Safety Evaluation Report

related to the construction of
Pilgrim Nuclear Generating Station,
Unit No. 2

Docket No. 50-471

This supplement presents the staff's analysis of Preliminary Safety Analysis Report (PSAR) Amendments 40 and 41, dated October 10, 1980 and March 16, 1981. These Amendments were submitted by the applicant in response to the Final Emergency Planning Rule (10 CFR Parts 50 and 70) and staff questions dated March 3, 1981.

Figure 13.2 Anticipated Pilgrim 2 onsite emergency organization

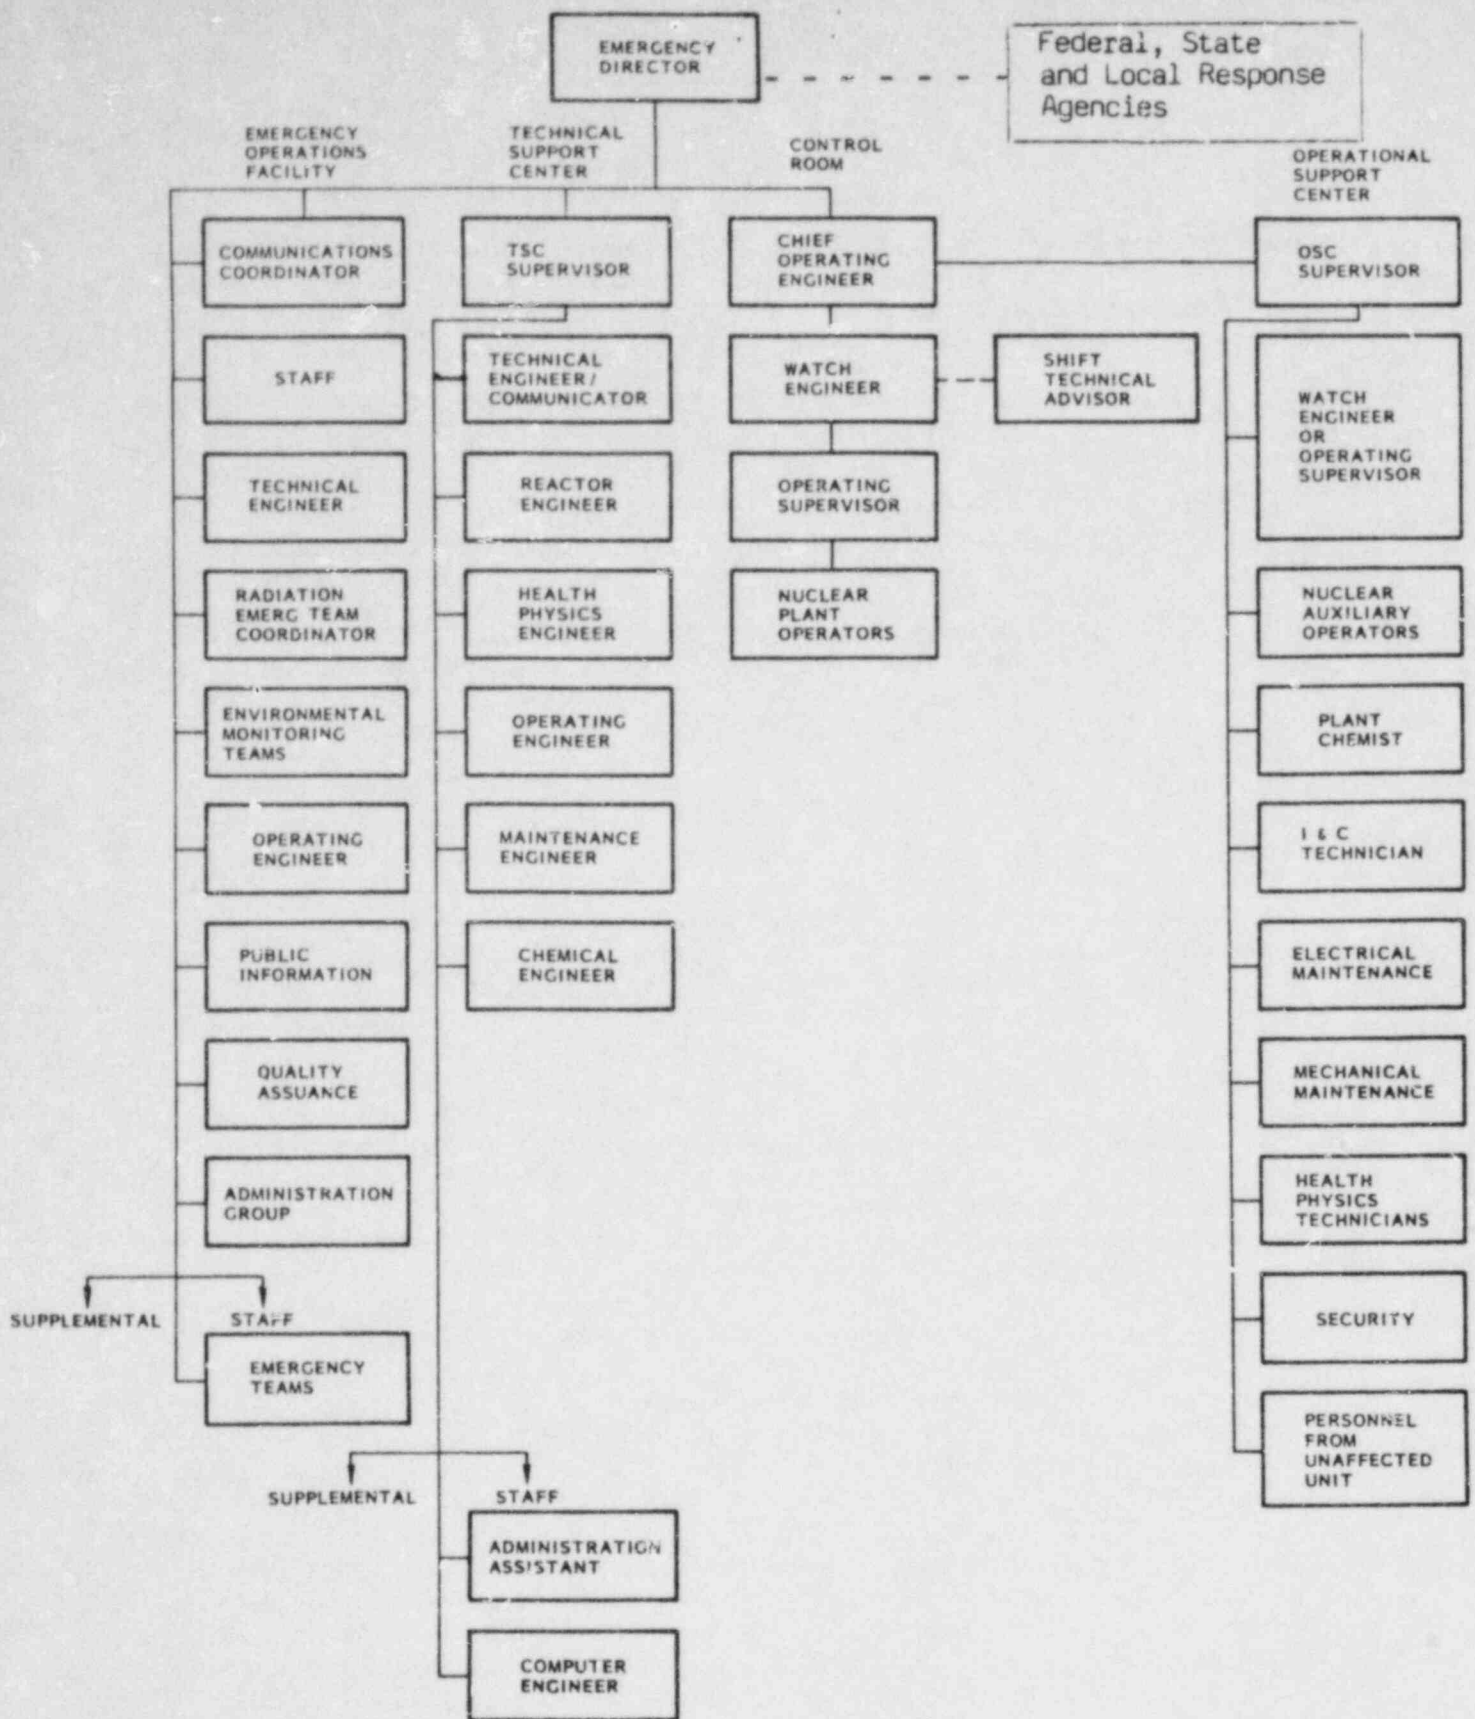
The Pilgrim Unit 2 emergency organization, described in PSAR Amendments 40 and 41, will consist of onsite and offsite Boston Edison personnel. Figure 13.2 shows the structure of the emergency organization including the primary point of interface with offsite support agencies listed in Table 13.1. The station workforce will be capable of meeting the minimum emergency staffing requirements of NUREG-0654, Table B-1 during normal working hours. During the backshift and on weekends, the onshift staffing levels will be met, call lists of offshift personnel will be used to augment the backshift to the levels specified in NUREG-0654, Table B-1 in the times specified. The applicants have identified the primary responsibilities of the major elements of the emergency organization. The on-duty Watch Engineer will become the Emergency Director, who will be responsible for accident assessment, accident classification, and the decision to notify offsite authorities and provide protective action recommendations to them.

Based on its review, the staff concludes that the information submitted by the applicant is sufficient to meet the requirements of Appendix E, Part II, Item A.

Appendix B

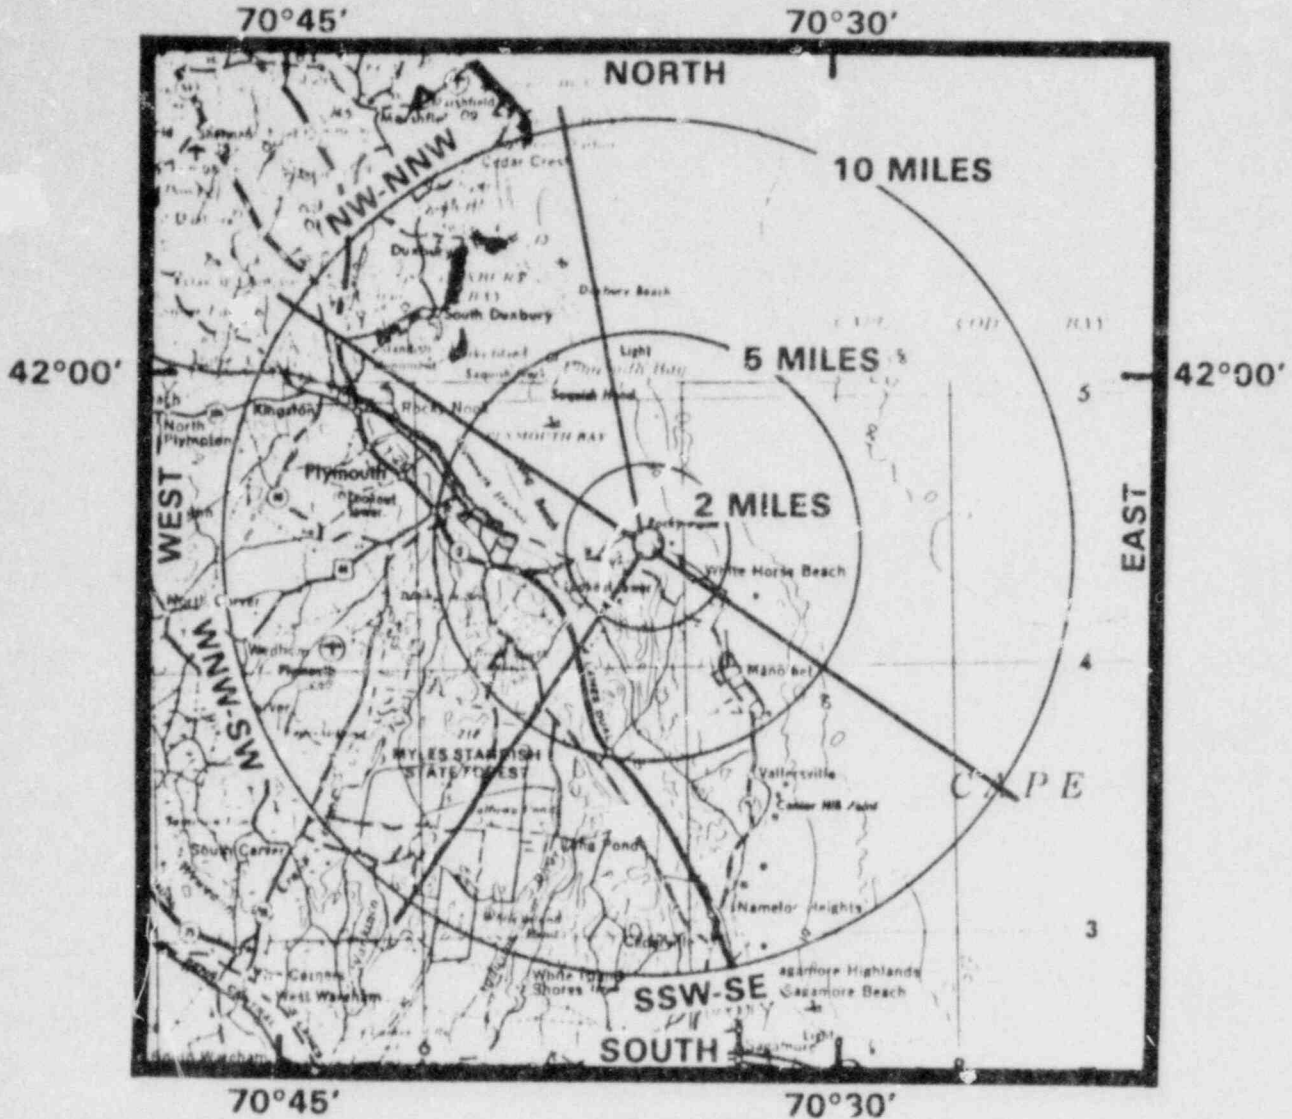
For the Pilgrim II plant, HMM Associates defined an EPZ which included several areas beyond ten miles. When reviewing the EPZ for the CLEAR calculations, it was determined that several intersections which could significantly effect the evacuation process lay beyond the EPZ defined by HMM Associates. As a result, an EPZ was planned for the CLEAR calculation to include these critical intersections. The analysis of this EPZ, labeled as the extended EPZ, proved beneficial in providing new information on this previously undefined problem area.

The omission of a critical bottleneck might leave the evacuation time estimates reported by the licensee open to some criticism. The problem area, approximately 11.5 miles from the Pilgrim Plant, is the rotary at the intersection of Route 3, Route 6, immediately north of the Sagamore Bridge which spans the Cape Cod canal. In the present analysis, it is assumed that the rotary will accept one lane of traffic at 15 mph. The effect of a segment with relatively minimal speed and capacity is to cause major traffic jams and delays. Furthermore, it is possible that vehicles backed up in a queue from this rotary will be within ten miles of the Pilgrim Plant. Consequently, the fact that calculations performed by HMM Associates did not address this major intersection which effects the evacuation of the Pilgrim II EPZ could cause difficulties for local government officials who might attempt to carry out an evacuation based on the estimates submitted by the licensee.

Further studies of the important intersections within the extended EPZ are recommended prior to inclusion of the evacuation time estimates into emergency evacuation procedures.
